Mansfield Bowling Club, Croftdown Road, NW5 1EP

2017/6499/P

Delegated Report (Members Briefing)		Analysis sheet		Expiry Date:	23/01/2018
		N/A / attached		Consultation Expiry Date:	n/a
Officer			Application Number(s)		
John Diver			2017/6499/P		
Application Address			Drawing Numbers		
Mansfield Bowling Club Croftdown Road London NW5 1EP			See draft decision notice		
PO 3/4	Area Team Signature	C&UD	Authorised Officer Signature		
Proposal Details of Hard and Soft Landscaping including tree replacement and railing details as required by condition 6 of planning permission ref 2015/1444/P allowed on appeal ref APP/X5210/W/16/3153454 dated 27/01/2017 (for demolition and replacement of bowling club building with part 3 and part 2 storey building for 21 residential dwellings and reconfigurations of the tennis facilities and pavilion).					
Recommendation:		Grant approval of details			
Application Type:		Approval of Details

Proposal: Details of Hard and Soft Landscaping including tree replacement and railing details as required by condition 6 of planning permission ref 2015/1444/P allowed on appeal ref APP/X5210/W/16/3153454 dated 27/01/2017 (for demolition and replacement of bowling clu

(Drawing AL4437-2001 REV C)

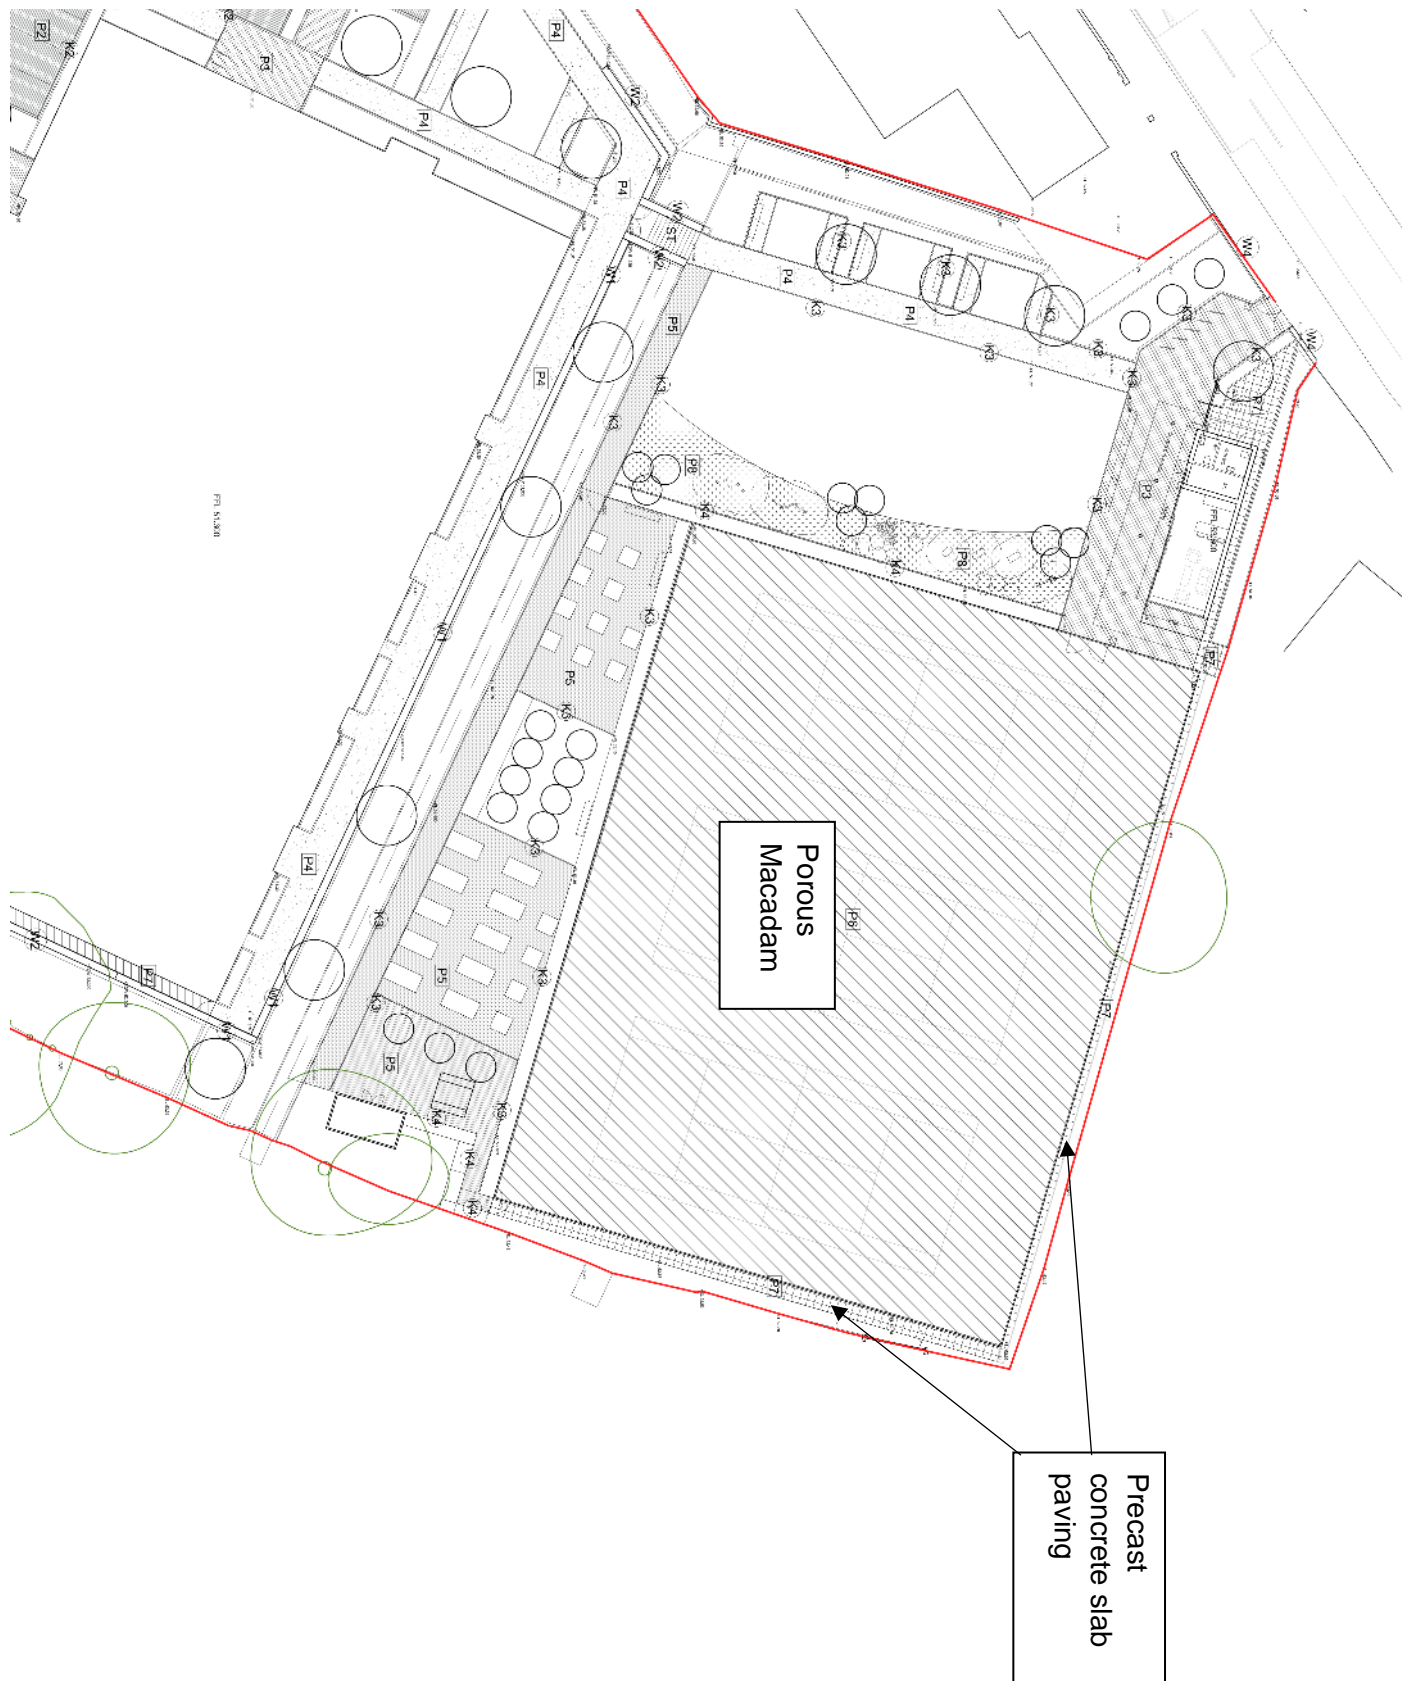
- 3.13. In respect to hard landscaping, details submitted include an updated annotated site plan, a sample panel of materials as well as section drawings showing surfacing and paving interfaces. Specifications of the porous Macadam surfacing for the tennis courts was also provided. With regard to hard surfacing, it is noted that the inspector made the following comment within the decision: *'At the hearing there was a discussion about car parking options which was addressed through correspondence following the hearing. The layout which is shown in drawing AA4437/2130 Rev F was the scheme on which the Council made its decision and it is on this basis that I have determined the appeal'* (para.48). The updated site plan aligned with the approved layout plan (AA4437/2130 Rev F) and hard surfacing plan (AL4437-2001 REV C) in that it does not show any amendment to the agreed parking, site access arrangements or location and quantum of hard landscaping (please see appendix four). For the purposes of condition six, only the chosen material palette for these areas remains outstanding.

- 3.14. Aside from the vehicular access/circulation to the South and the porous macadam surfacing to the tennis courts (discussed further below), all other hard surfaced areas would be provided in a mixture of granite paving (small and large modular), permeable paving (for car parking bays and allotment areas) and a buff coloured self-binding gravel for the footpath to the South of the courts. Kerbstones would also be provided in granite to match paving. This palette of materials would provide a suitable range of tones and textures to complement the built forms as well as landscaped areas of the site. The areas of gravel and permeable paving would also improve surface-water drainage and reduce run-off rates. The materials are considered to remain appropriate for their setting as and the Conservation Area.
